**ADDENDUM NO. 1**

RE: **Benevola Newcomer Road / Stream Restoration**  
**Washington County Contract Number: RD-BN-274-10**

**BENEVOLA NEWCOMER ROAD / STREAM RESTORATION**  
**Washington County Contract No. RD-BN-274-10**

SHEET NO.  
03R OF 15

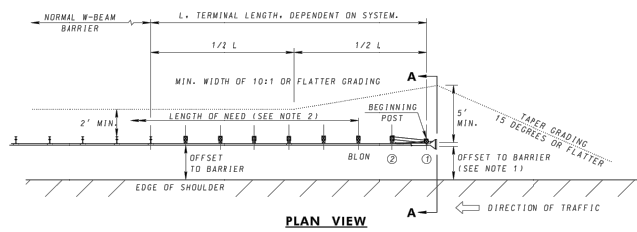
2. Plan sheet 3 of 15 shows the HMA Wedge and Level for only half of the existing roadway. The pavement widening detail on sheet 15 of 15 shows the wedge and level for the entire width of the existing roadway. Is it the intent to pave (wedge and level) the entire roadway width?

20. Bid item 602 Traffic Barrier Type "B": It appears the end section located at STA 0+50 should Type C instead of Type B. If this is correct, then the quantity should be updated and Type C should be added to the bid form.

**Response: Wedge and Level shall be across the entire width of the existing roadway. Plan sheet 3 and the quantity for this item have been adjusted.**

**Response: Type B end sections have been changed to Type C on the plans and in the Bid Forms. The location of the end section near Station 3+00 has been moved closer to the roadway.**

1. Sheet 3 of 15 - For Traffic Barrier and Wedge and Level

SCALE  
 NONE  
 SHEET NO.  
 14R OF 15  
 PROJECT NO.  
 10-274

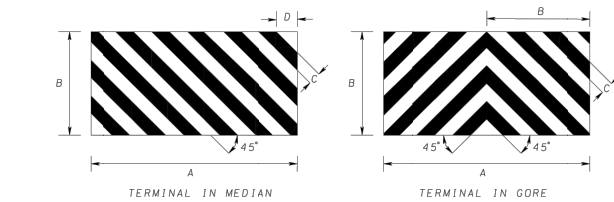
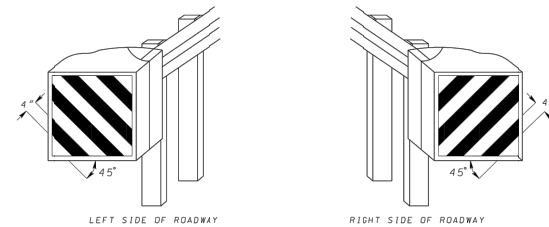
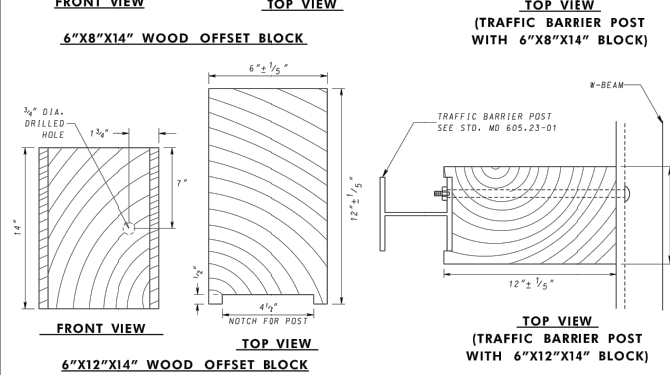
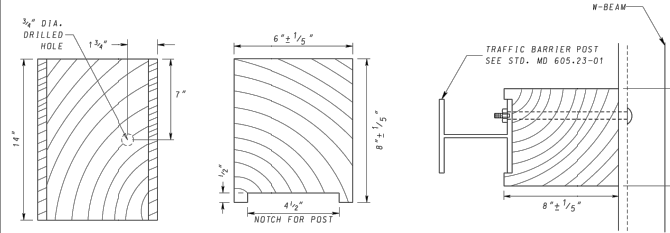
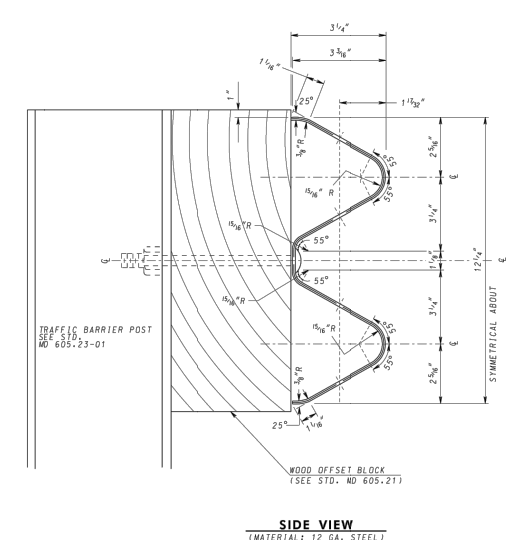
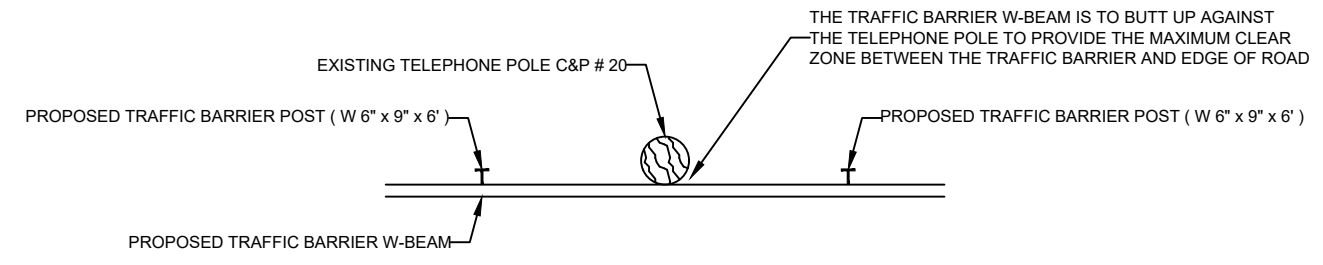
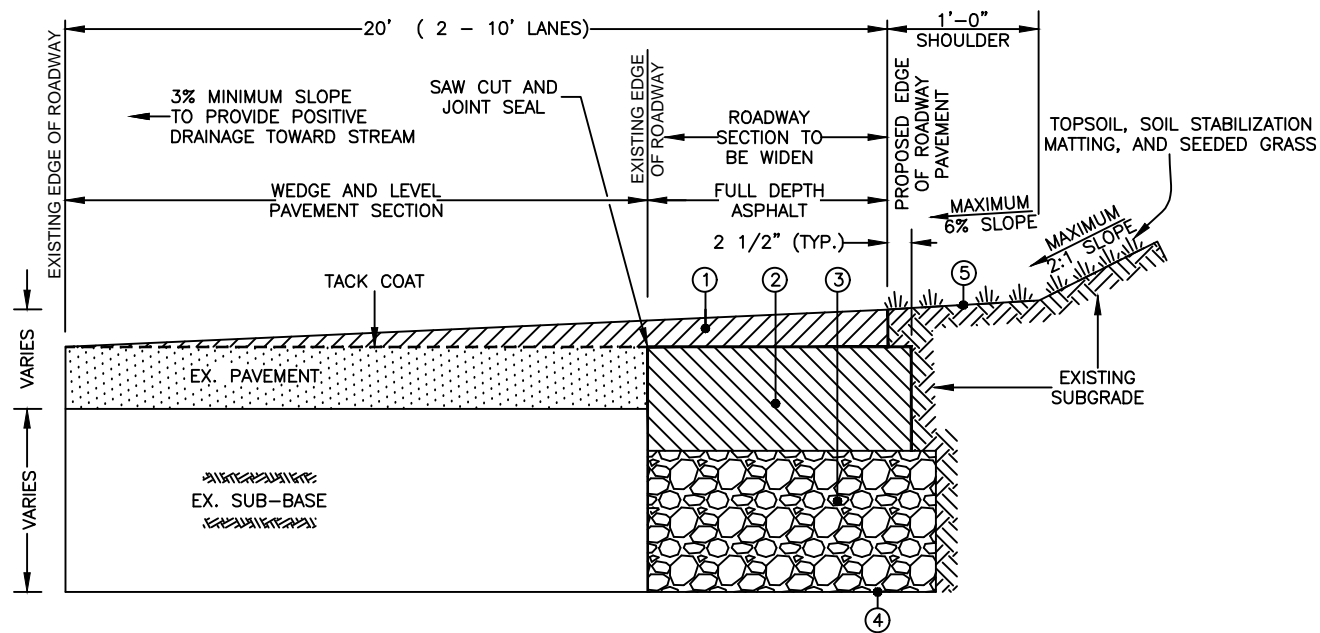
2. Sheet 14 of 15 – For detail revision

7. Item 602 Traffic Barrier Type "B" End Treatment: change Item to Traffic Barrier Type "C" End Treatment
